Re: Errors in TCB Grant of Certification for ReconRobotics Recon Scout;
FCC Identifier UYXRSK2010-01; Licensed Non-Broadcast Station
Transmitter; American TCB, Inc. date of grant 04/22/2010.

Errors and Issues in the Testing and Certification of the ReconRobotics Recon Scout

Figure 1 - This graph from the test-result report shows the measured bandwidth of the Scout when operated on with an apparent video carrier at 445 MHz.

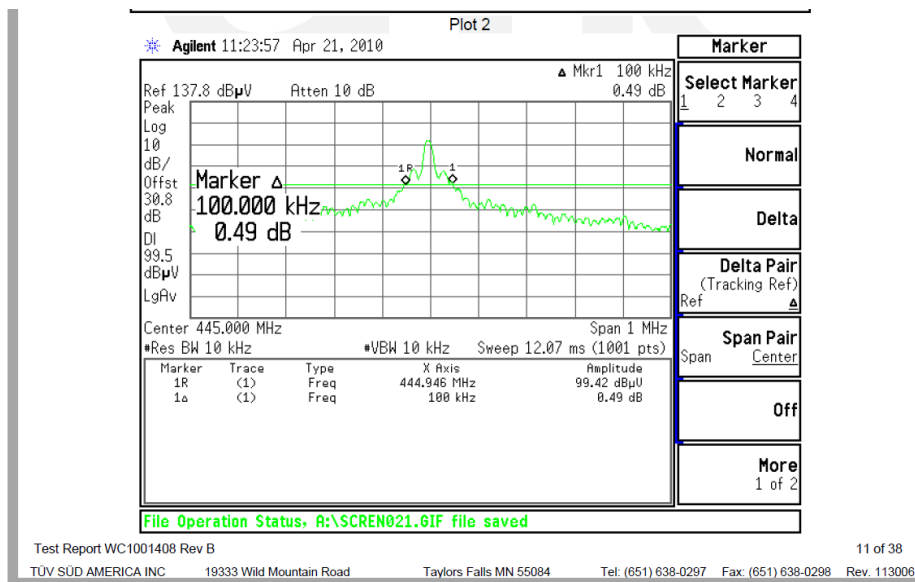
Figure 1 below, taken from the ReconRobotics Scout test-result report, shows the reported occupied bandwidth of the transmitter. This measurement is by no means representative of the bandwidth of an NTSC analog video signal. Part 2 is not explicit as to the modulation test conditions for a transmitter using C3F emissions, but the loosest possible interpretation of the rules would allow the use of the provision of §2.1049(i):

This provision notwithstanding, it is clear from the test results that the modulation applied to the device was far from that which would produce a typical bandwidth reasonably representative of the actual necessary bandwidth for an AM vestigial-sideband video transmitter. The results look closer to what would be seen if the Scout camera were looking at a well-lit room with few features. (Not surprisingly, this could describe a typical shielded test room.) Although it is recognized that it is not practical, nor typical, to apply an external video signal to the Scout, it is also technically incorrect to make a measurement of occupied bandwidth that does not specify in any way the modulation conditions or input signal (as required by §2.1049(i)) especially when the result is obviously so radically different than the known necessary bandwidth of an NTSC video transmitter. It would be much more reasonable to measure the occupied bandwidth under the darkest lighting conditions apt to be reasonably and typically encountered by the Scout, as this is the modulation that would produce the greatest, not the least, energy in the modulation sidebands. Having apparently made this measurement to the standards which apply to an FM or PM transmitter, using a -20 dB criterion for establishing occupied bandwidth simply compounded this testing error to the point where the end results don't even make sense. In this context, ReconRobotics' continuing justification of the emissions designator and the bandwidth testing is inexplicable.

Other questions about whether this device was operating at its maximum power level notwithstanding (see below), ARRL recognizes that it is likely that the device's occupied bandwidth would fall within the range acceptable for the necessary bandwidth of the device or the allocated 6 MHz channel. It must also be recognized that this determination cannot be reasonably made from the provided data in the test-result report. This is best demonstrated by the Figures below. Figure 1 shows the reported measured occupied bandwidth of the Scout.

The test conditions that existed when the occupied bandwidth measurement of Figure 1 was taken were neither typical nor a reasonable representation of the occupied bandwidth that would be encountered in actual use. Figures 2 and 3 below show measurements of

The only accurate measurement that could be made of the occupied bandwidth of an NTSC video signal would be to look at the emission across its entire necessary bandwidth and make a technical and accurate determination of the points above and below the center of the channel that represented the 99.5% energy points in the upper and lower direction.

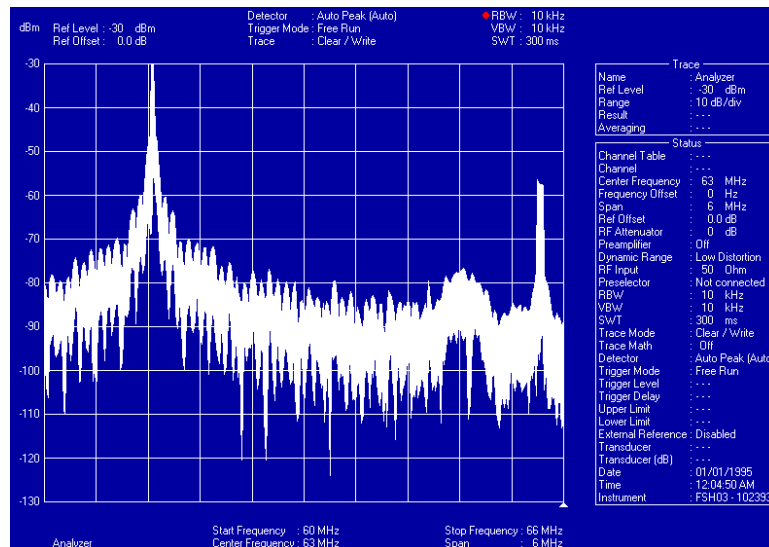
What is evident from the comparison of the bandwidth of the signal transmitted during the testing of the Scout and the bandwidth of the two extremes of the ranges seen in Figures 2 and 3 above is that the modulation of the Scout was not close to the modulation that would produce a reasonable representation of the range of occupied bandwidth that would be seen during typical operation of the device under test. This is another area where the test result report does not support a certification grant, and therefore the applications that specified the erroneous emission designator in the certification grant are in error as well.
